**IECC COMMERCIAL COMMITTEE ACTION REPORT ON THE
RESULTS ON THE 2021
PUBLIC INPUT CHANGES TO THE
INTERNATIONAL ENERGY CONSERVATION CODES-UPDATED 7/19/22**

Update July 19, 2022

The Glide Path
 Zero net energy by 2030
 10/19/21 version

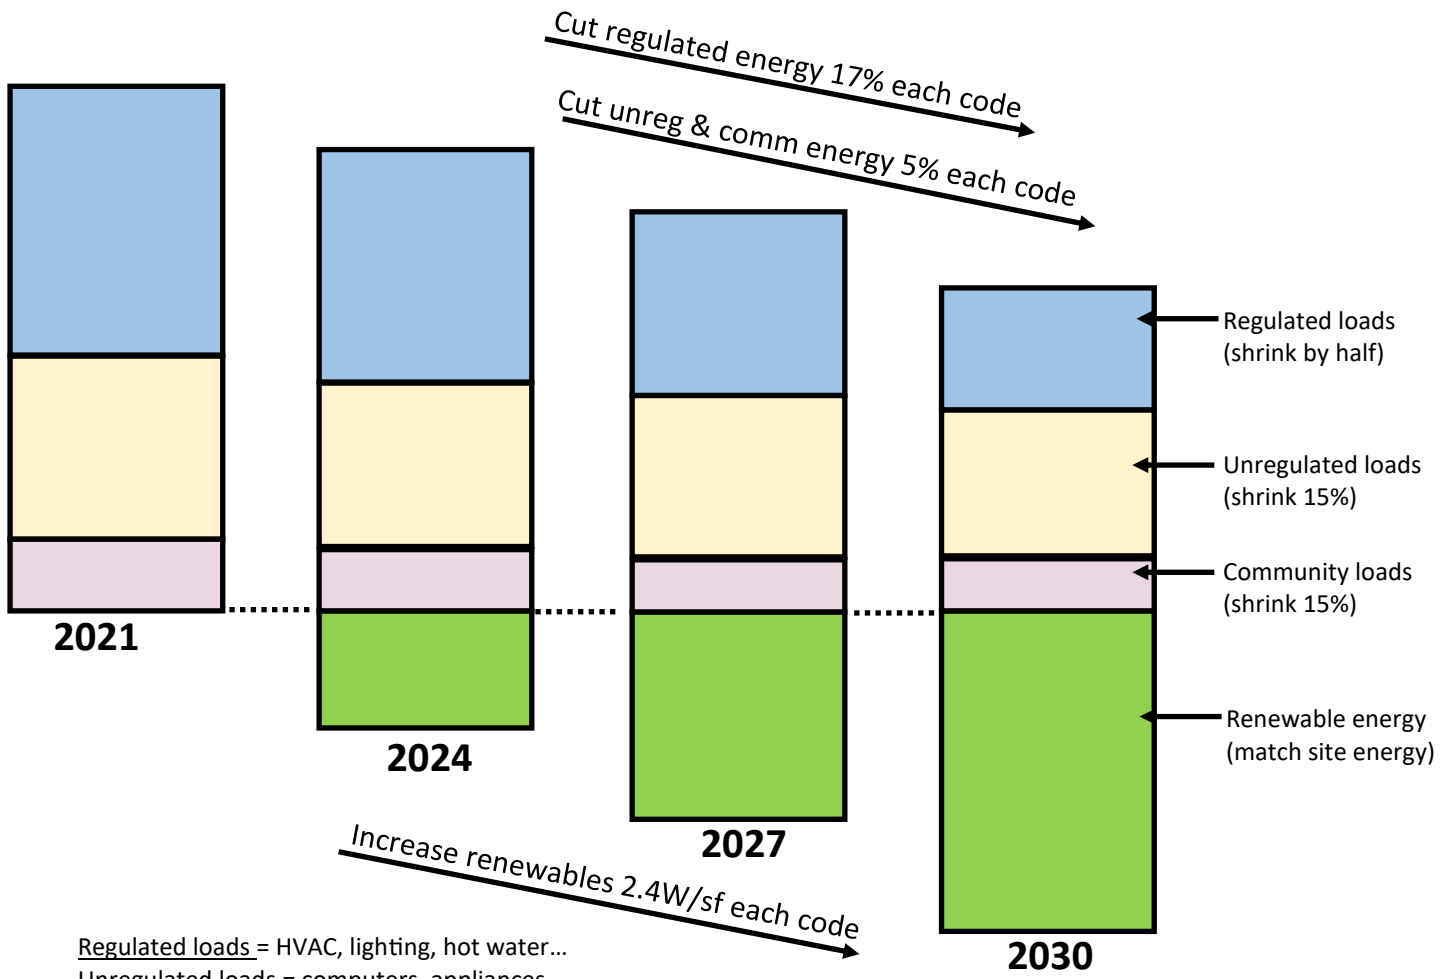
Reason: This appendix is intended to be adopted by jurisdictions that will require new construction to operate at net zero energy by the year 2030. It reduces the net annual energy use of buildings by approximately one-third in comparison with buildings constructed in compliance with the 2021 IECC, assuming that the 2027 and 2030 editions will also reduce energy use by one-third each.

It is estimated that *regulated* energy uses in buildings can be cut by 50% from current levels by 2030, but that unregulated loads and large community process loads will only diminish about 15% in the same time period. If regulated loads comprise 60% of building energy use, and unregulated loads (not counting large process loads) comprise the remaining 40%, halving the regulated loads would result in a 30% reduction in energy use, or 10% for each of the three Glide Path steps. Reducing unregulated and process loads by 15% over this decade would result in an additional 9% overall building energy use reduction by 2030, or 3% reduction per code cycle. Some of this 13% reduction (10% regulated and 3% unregulated/process) will occur in the base code development, and the remainder is required by this appendix.

For the 2030 ZNE target, renewable or site-recovered energy will be required to compensate for the remaining half of regulated energy use, plus the typical unregulated building energy use, and an additional amount to cover a proportionate share of community process energy.

Rather than burdening those buildings that contain large process loads (restaurant, grocery, hospital, data center, laboratory, etc.) with a requirement to provide renewable energy to cover their entire operating energy use, this Appendix requires an additional amount of renewable energy for *all* new building square footage in recognition of the fact that those large process loads serve the entire community with essential services. It is estimated that such community process loads equal approximately 20% of all other building energy loads.

If 39% of a building's net energy use reduction can be covered with efficiency and technology improvements, the remaining 61% of the *net* energy use reduction will be accomplished with acquisition of renewable energy resources, also in three roughly equal steps. Assuming typical PV production to be 1.5 kWh/year/watt, this would result in a requirement for 7 W/sf of conditioned floor area for 2030, or roughly 2.4 W/sf for 2024. For semi-heated or unconditioned space, the requirement will be 1/3 of this amount, or 0.8 W/sf for 2024.

Commercial Energy Committee Committee Action: As Modified

Commercial Energy Committee Reason: This proposed appendix establishes a pathway to net-zero energy consumption by 2030.
